SCL 26 kV and Power Relocation

Seattle City Light
CONSTRUCTION STANDARD
Requirements for Duct Banks in the Public Right-of-Way

SR 520	U1
MONTLAKE TO LAKE WASHINGTON	
I/C AND BRIDGE REPLACEMENT	
26 KV RELOCATION

**26KV LINE RELOCATION
STAGING Rev00**

Figure 4.1. General Duct Bank, End View

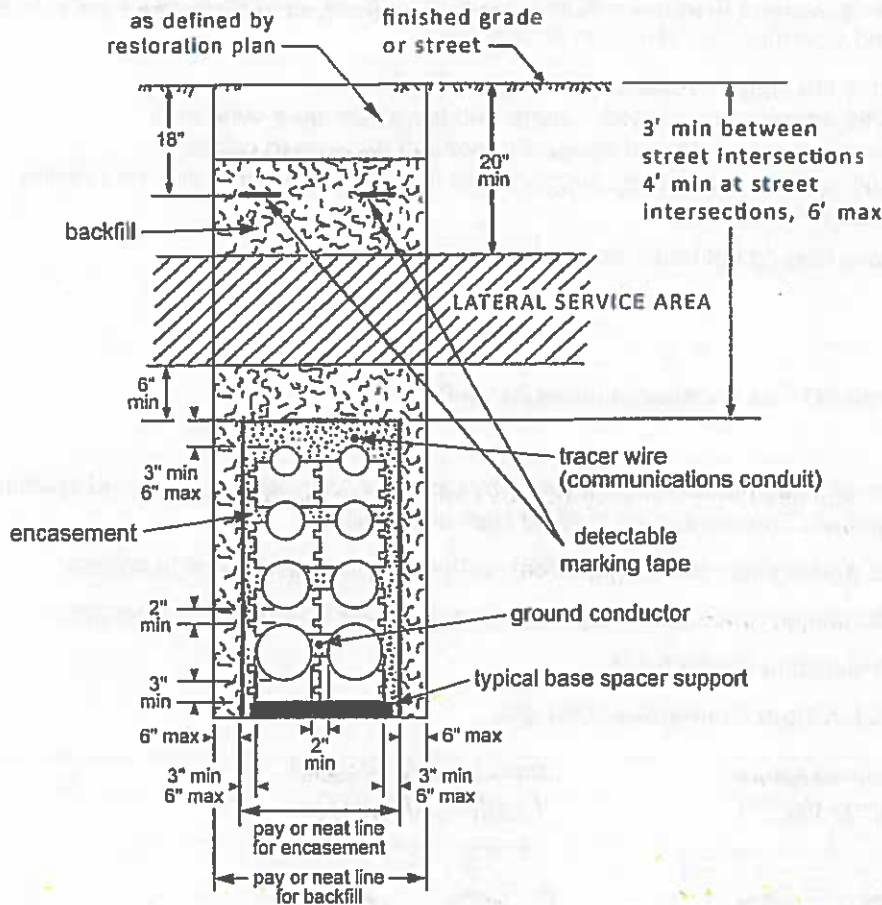
20" W x 12" D duct bank required. Assumed only 12" cover acceptable with steel plating under roadways. 12" cover allowed under planter areas per Technical Requirements.

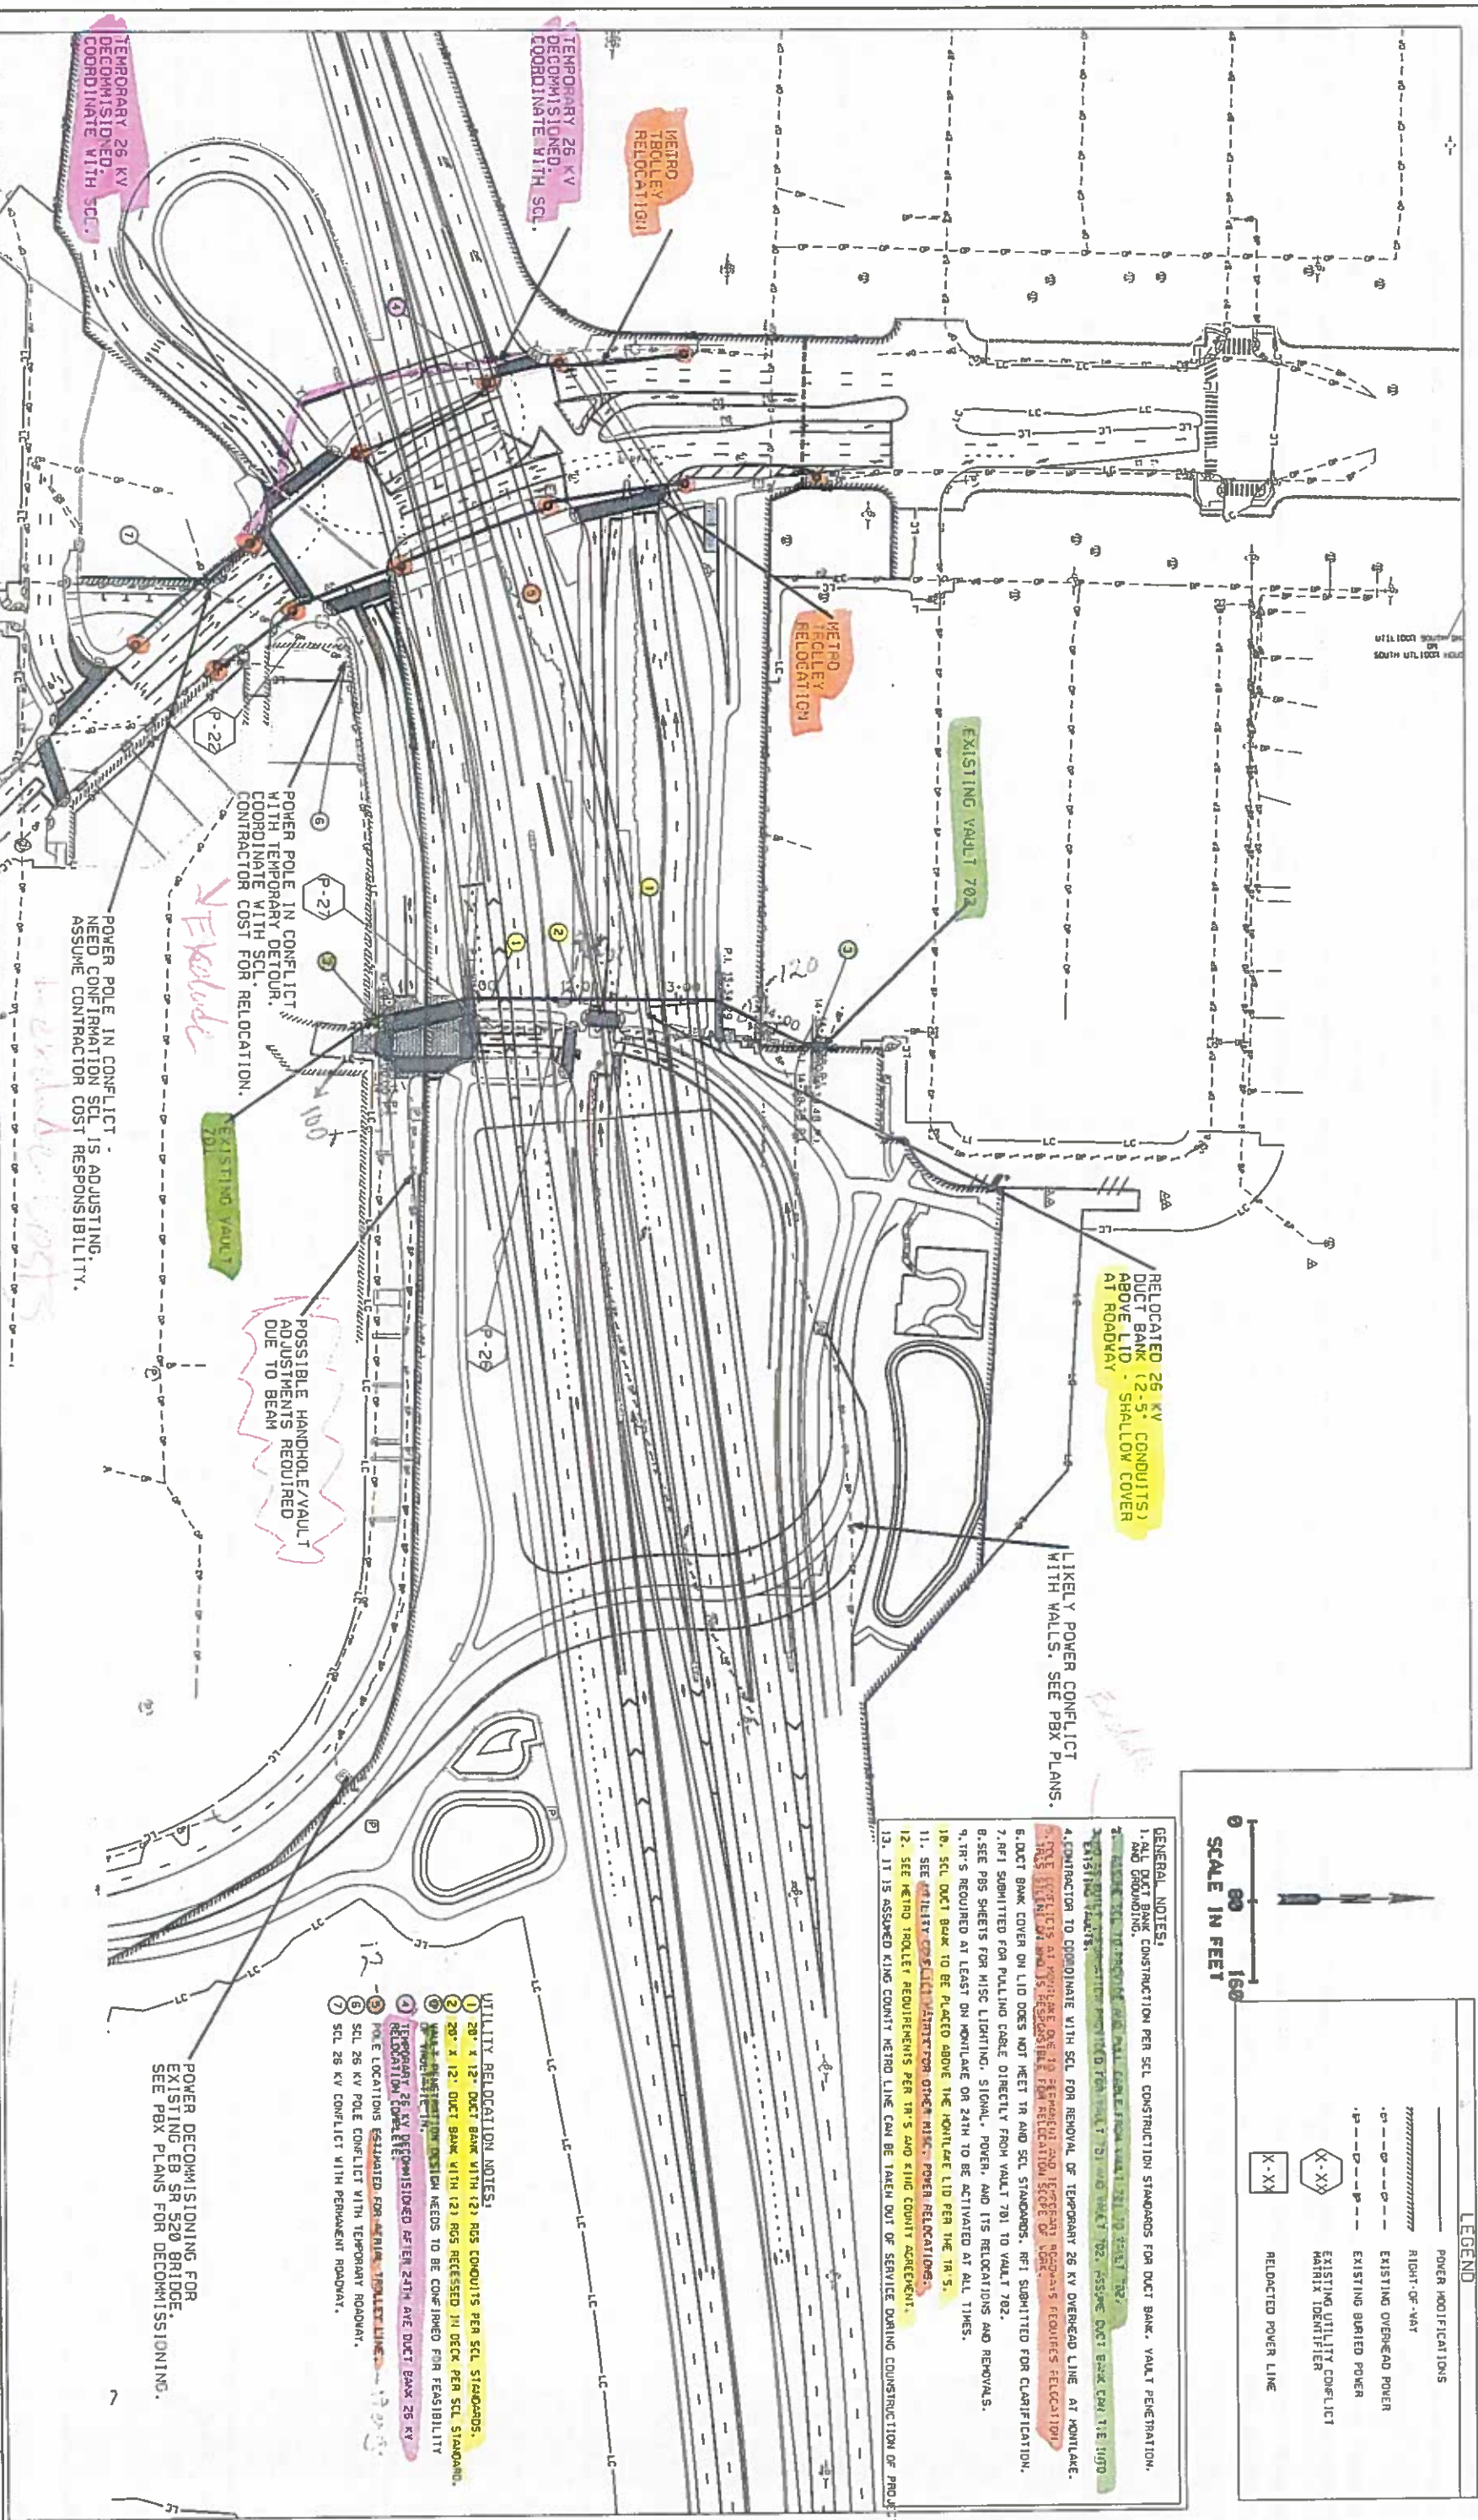
4. DUCT BANK COVER ON LID DOES NOT MEET TR AND SCL STANDARDS. REI SUBMITTED FOR CLARIFICATION.
 5. RFI SUBMITTED FOR PULLING CABLE DIRECTLY FROM VAULT 701 TO VAULT 702.

- UTILITY RELOCATION NOTES:**
1. 20" x 12" DUCT BANK WITH (2) RGS CONDUITS PER SCL STANDARDS.
 2. 20" x 12" DUCT BANK WITH (2) RGS RECESSED IN DECK PER SCL STANDARDS.
 3. VAULT RELOCATION DESIGN NEEDS TO BE CONFIRMED FOR FEASIBILITY OF IMPLEMENTATION.
 4. TEMPORARY 26 KV DECOMMISSIONED AFTER 24TH AVE DUCT BANK 26 KV RELOCATION COMPLETED.
 5. POLE LOCATIONS ESTABLISHED FOR METRO TROLLEY LINE.
 6. SCL 26 KV POLE CONFLICT WITH TEMPORARY ROADWAY.
 7. SCL 26 KV CONFLICT WITH PERMANENT ROADWAY.

POWER POLE IN CONFLICT WITH TEMPORARY DETOUR. CONTRACTOR COST FOR RELOCATION.

POWER POLE IN CONFLICT WITH TEMPORARY DETOUR. NEED CONFIRMATION SCL IS ADJUSTING. ASSUME CONTRACTOR COST RESPONSIBILITY.

POSSIBLE HANDHOLE/VAULT ADJUSTMENTS REQUIRED DUE TO BEAM

RELOCATED 26 KV DUCT BANK (2-5" CONDUITS) ABOVE LID - SHALLOW COVER AT ROADWAY

LIKELY POWER CONFLICT WITH WALLS. SEE PBX PLANS.

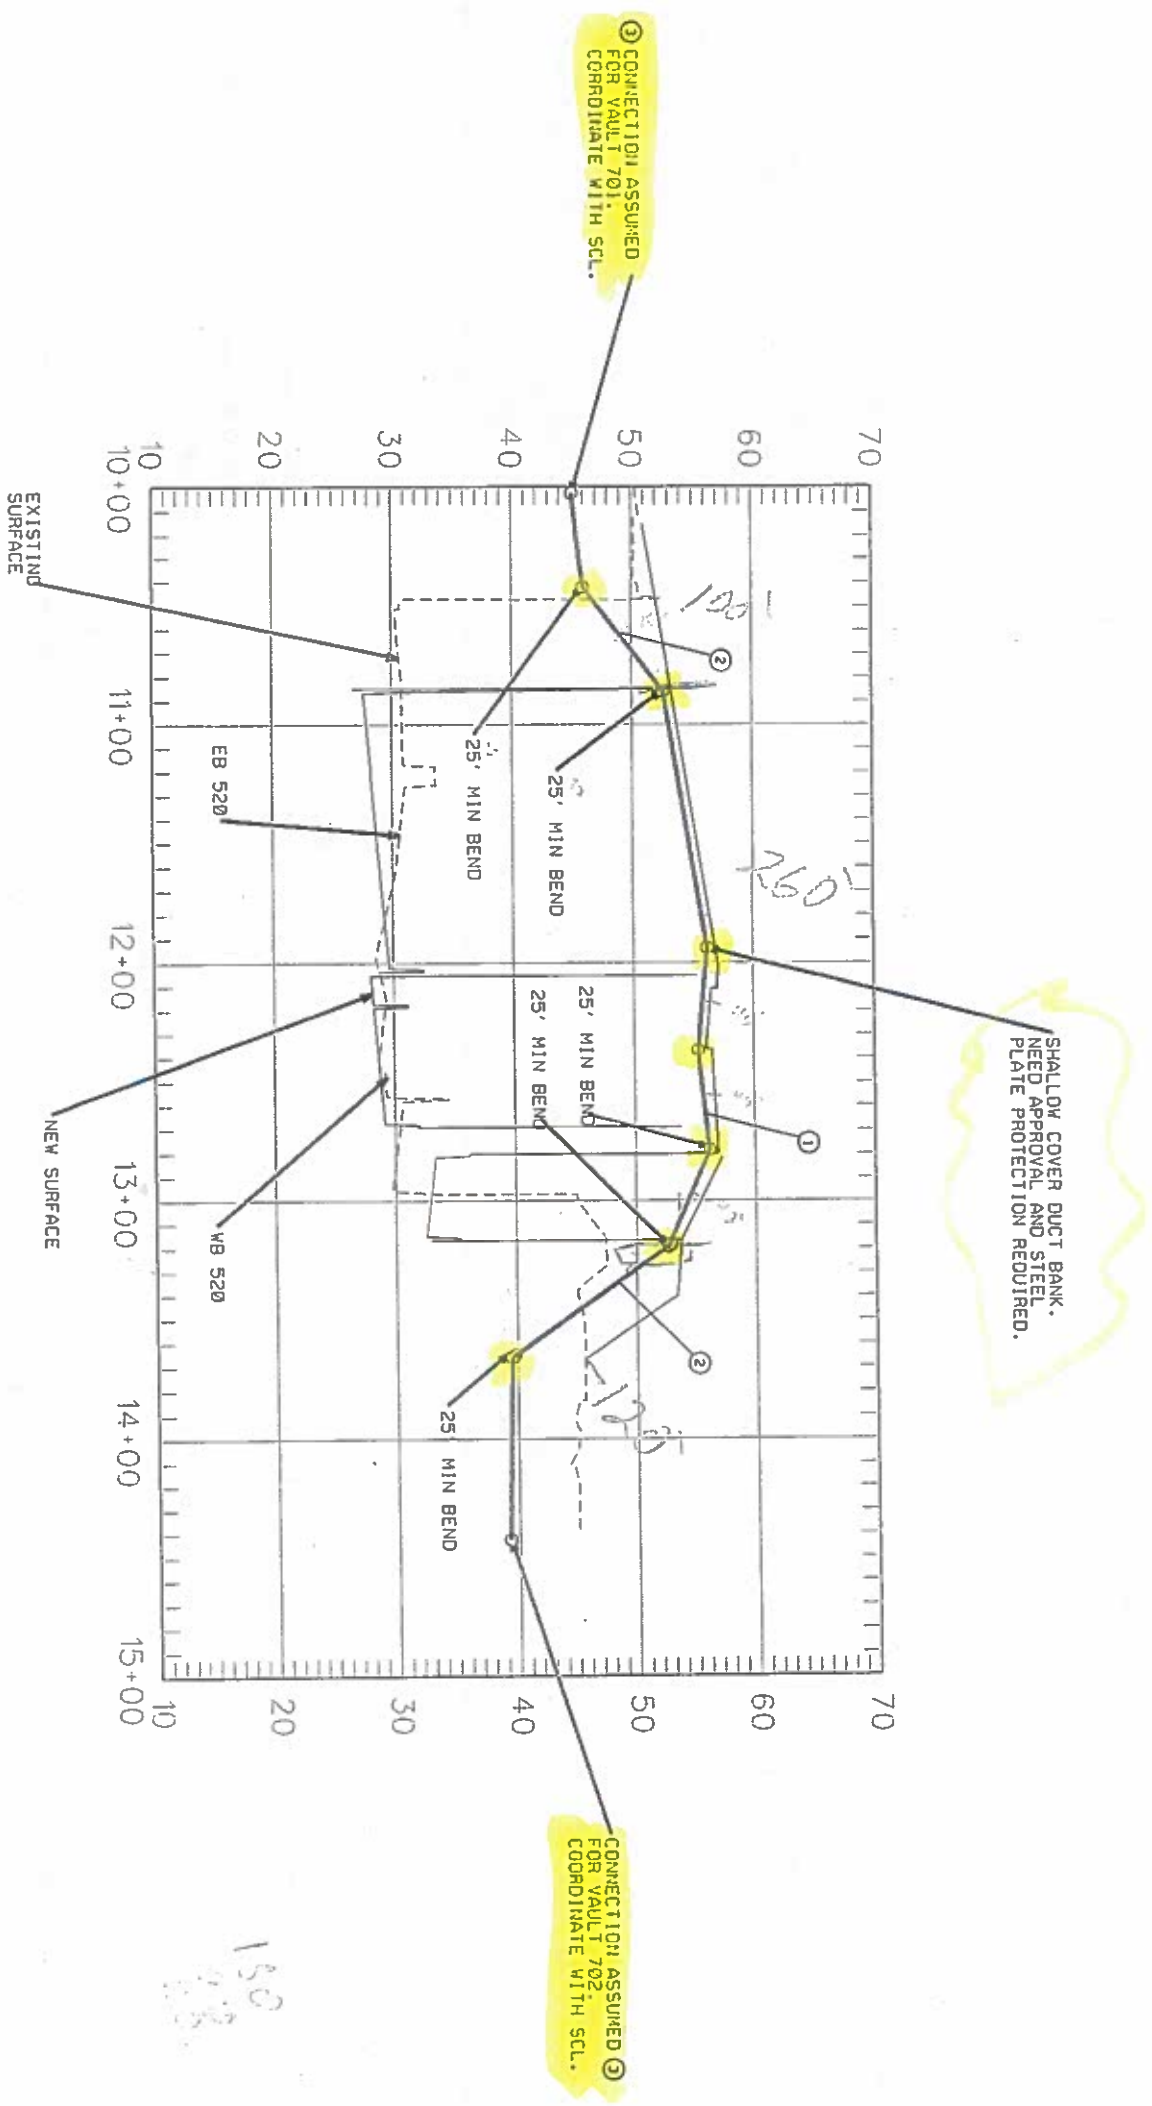
GENERAL NOTES:
 1. 3" STANDARD COVER REQUIRED FOR DUCT BANK.
 2. ASSUMED LESS THAN 3" COVER ACCEPTABLE OVER MONTLAKE LID.
 3. SEE PLAN FOR FURTHER INFORMATION.
 4. SHALLOW COVER ON LID ASSUMED ACCEPTABLE.

UTILITY RELOCATION NOTES:
 ① DUCT BANK 28" X 12" WITH TWO RGS CONDUITS AND 12" MINIMUM COVER.
 ② DUCT BANK TO MEET SCL CONSTRUCTION STANDARDS.
 ③ CONNECTION OF DUCT BANK TO VAULTS NEED TO BE CONFIRMED.
